平陆县 100MW 农光互补光伏发电项目

监理工程师通知单

编号: ZHJL-JLTZ-PL-176

主题: 2024 年 12 月 28 日、29 日建设单位、监理单位及总包单位在西沟光伏区验收过程中发现以下问题:

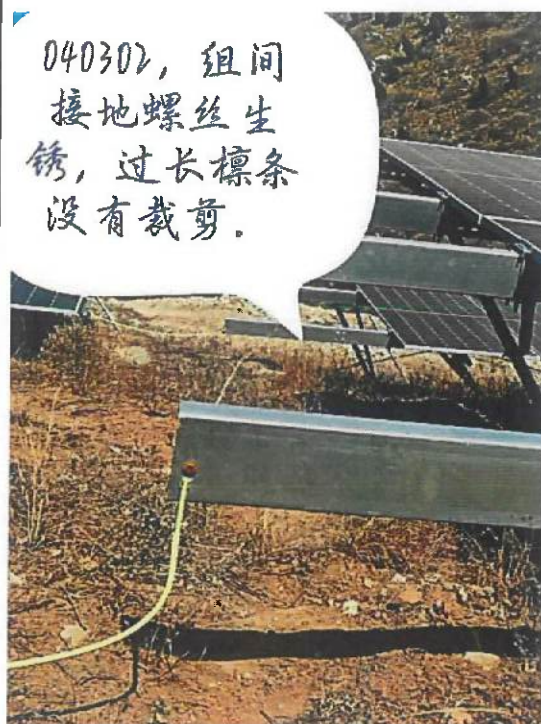
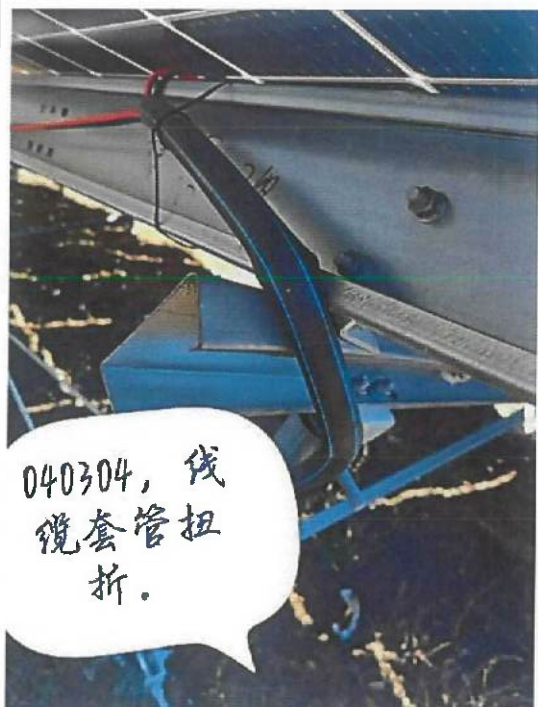
1	 040321 斜撑 不受力。	2	 040325, 两处背拉杆需要交叉固定, 加延长管。
3	 040320, 背 拉杆需加上 延长管。	4	 040324到01, 多 处背拉杆未做好 交叉固定, 整改 需要加长管。

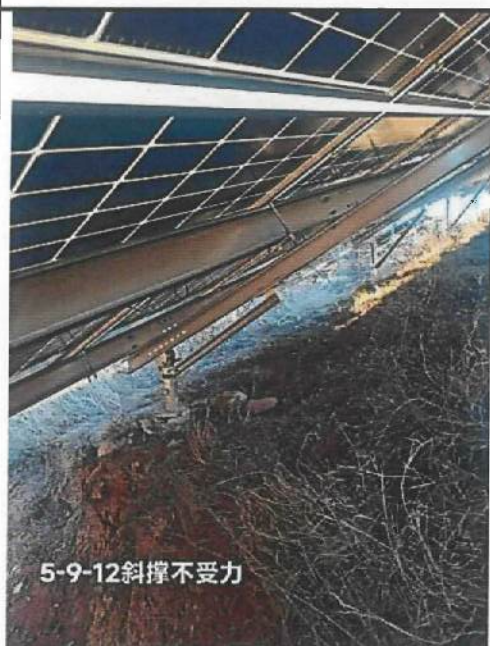
040304, 线
缆套管扭
折。

040306, 电
缆套管扭
折

040306压
块变形。

040315, 扎
丝生锈。

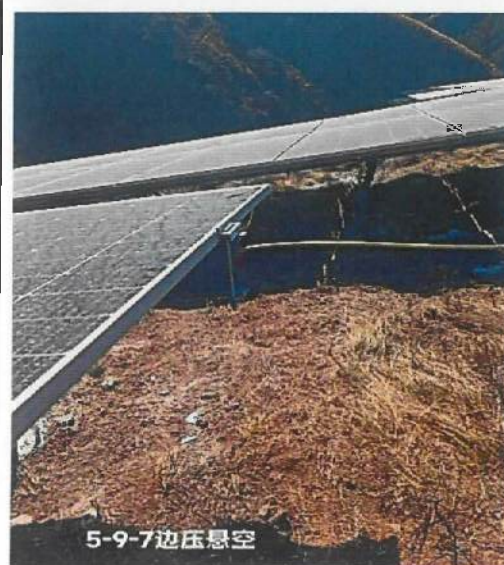
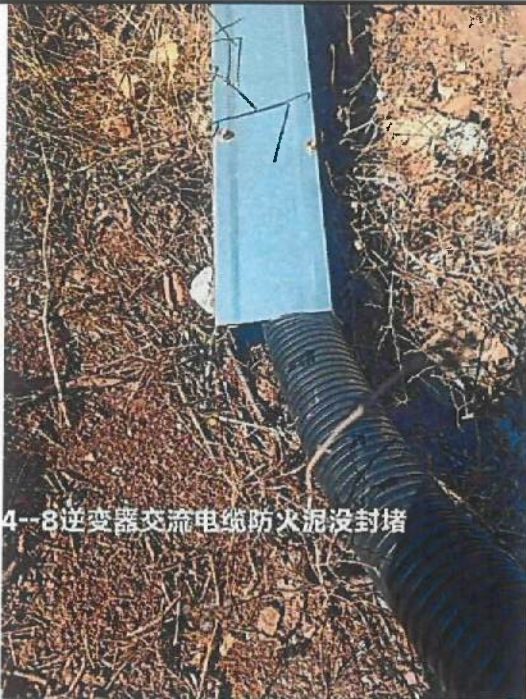
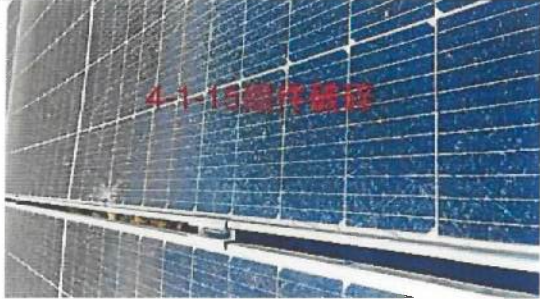
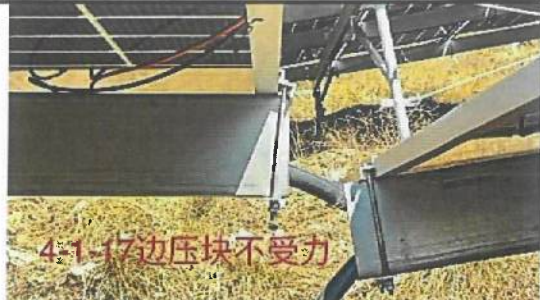
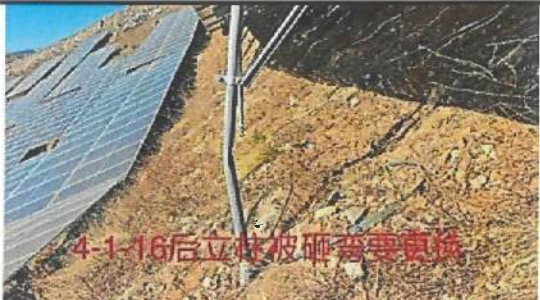
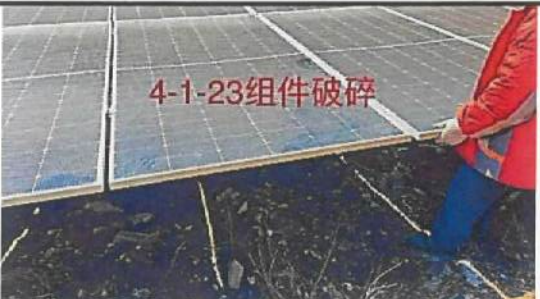
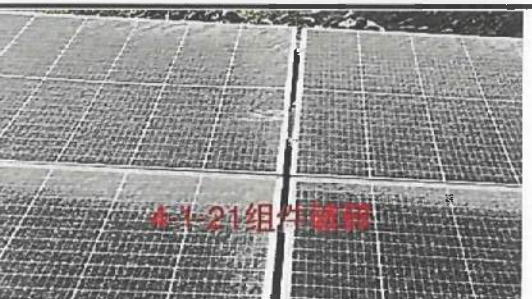
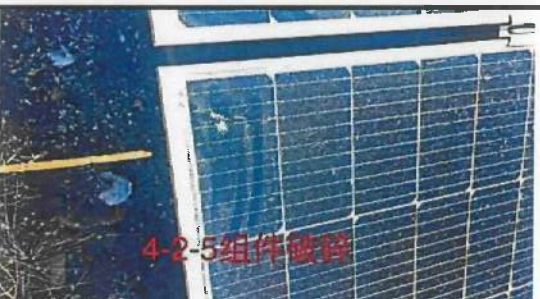
21	 4-8-12电缆套管绑扎	22	 4-8-7缺少斜撑
23	 4--8逆变器交流电缆防火泥没封堵	24	 4-1-1缺少元宝垫
25	 4-1-6斜支撑不紧力	26	 4-1-15组件缺失

37	 4-7-12旁压块未掩埋	38	 4-7-12压块边距不够
39	 4-6-28标识翘起	40	 4-6-2U型螺栓生锈
41	 4-5-21螺丝生锈	42	 4-5-20缺少螺丝
43	 4-5-20标识条连接件处开孔	44	 4-4-14跨接线生锈

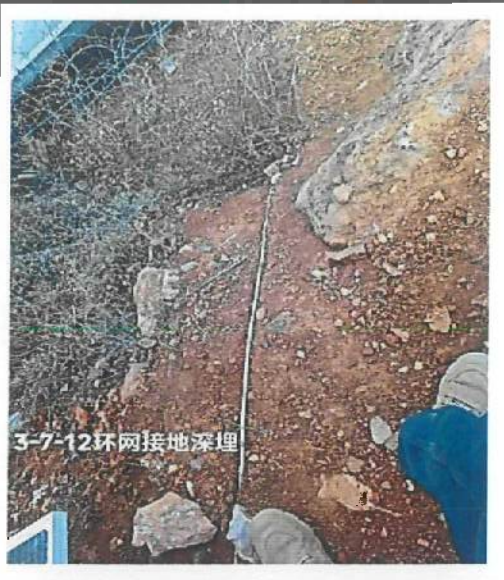
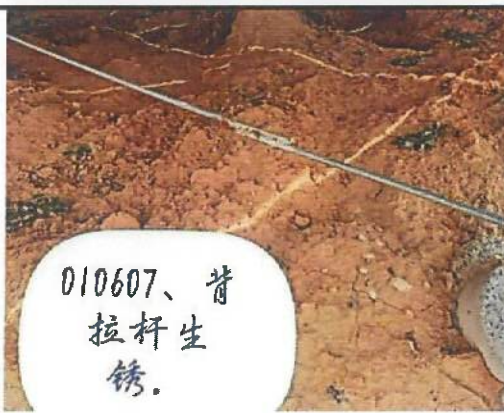
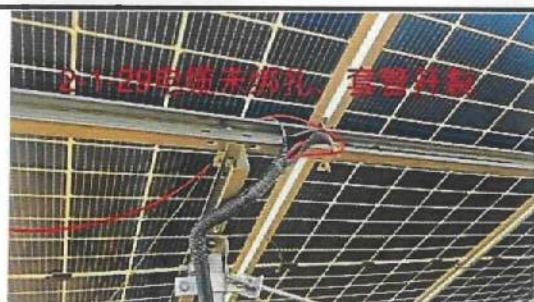
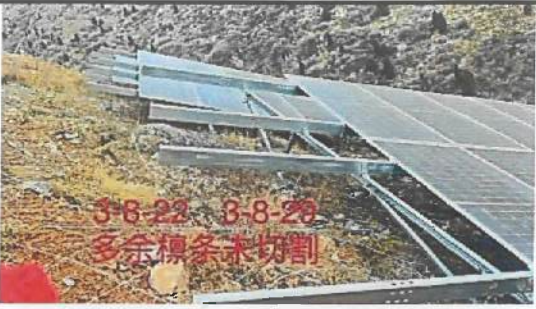
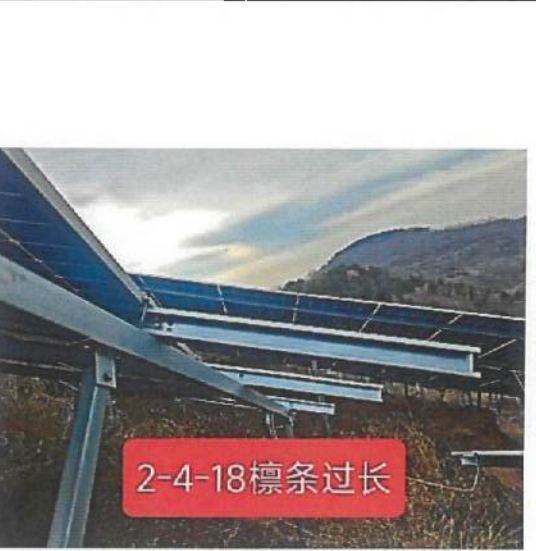
141	 3-6-11环网接地外露	142	 3-7-12环网接地深埋
143	 010607号码管破损。	144	 010607、背拉杆生锈。
145	 040607, 斜拉杆未露丝	146	 0107逆变器防水封堵。
147	 0107逆变器下方电缆没有绑扎固定。	148	 010722套管不够长。

161	 4#箱变8#逆变器电缆管未绑扎 接地未连接接地网 包箍生锈	162	 3-8-22 3-8-28 多余檩条未切割
163	 3-4-4地线接地连接螺 丝生锈	164	 2-5-13四平方电缆需要绑 扎
165	 2-4-11四平方电缆需要绑 扎	166	 2-4-18檩条过长
167	 2-4-3拉杆长度不够，无法 安装双螺母	168	 2-4-5檩托未开孔，缺少螺 栓
